**AMENDMENTS TO THE DRAWINGS:**

## **REMARKS**

### **II. THE DRAWING OBJECTIONS**

Fig.3.

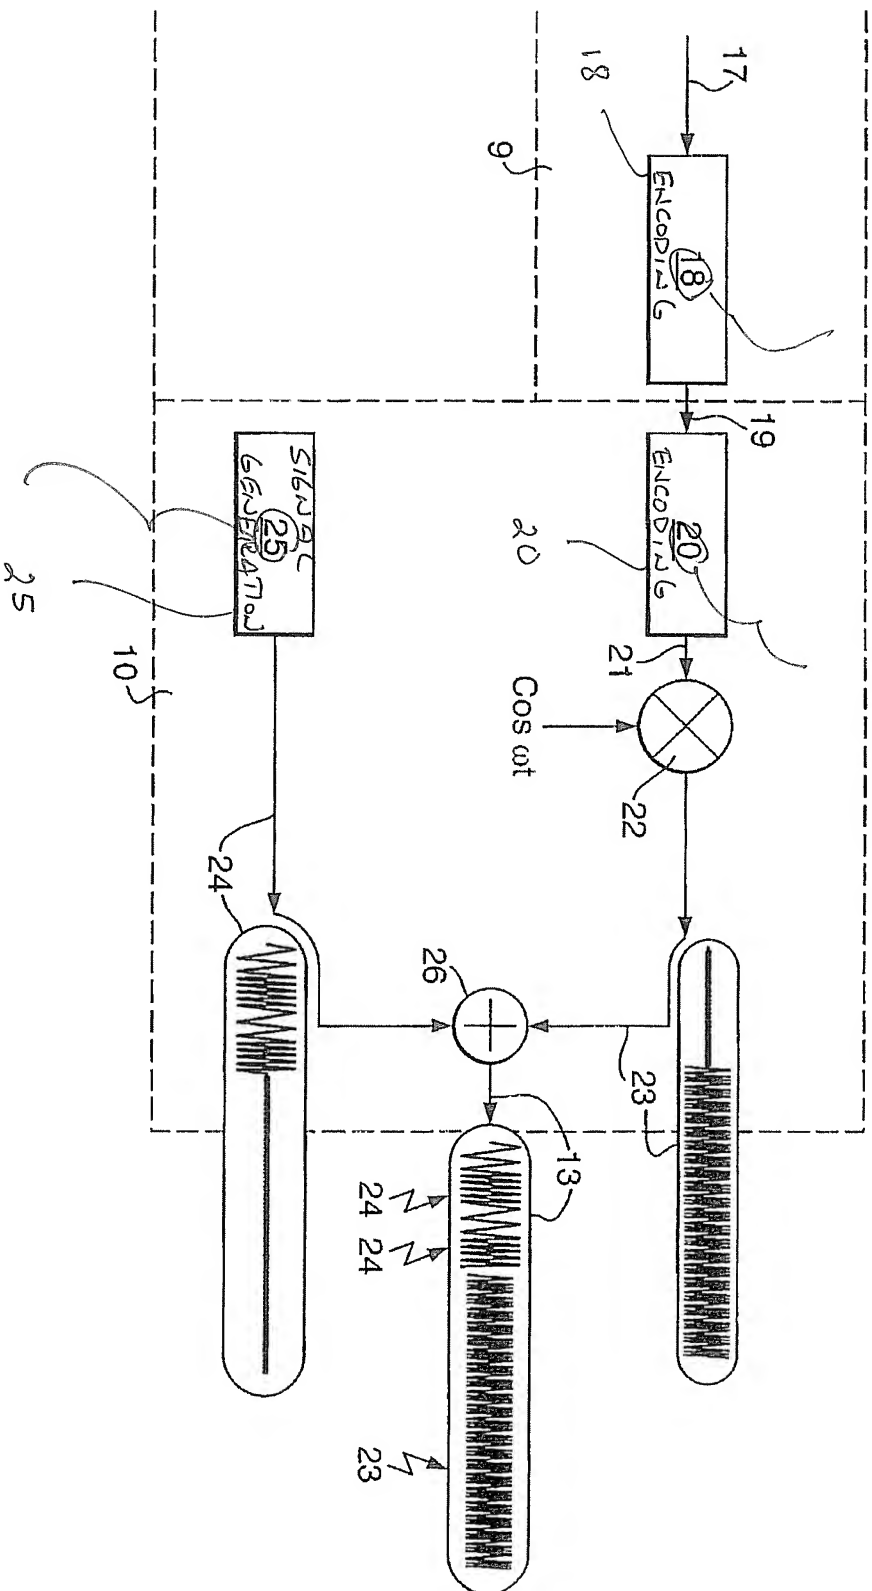
The examiner objected to Figures 2-3 and 5 for lacking descriptive labels.

The examiner's objection is overcome by amending Figures 2-3 and 5 to include the appropriate descriptive labels. Marked up sheets for Figures 2-3 and 5 showing Applicant's proposed Figure changes are attached at Appendix A of this paper. Replacement sheets for Figures 2-3 and 5 are attached a Appendix B of this Reply.
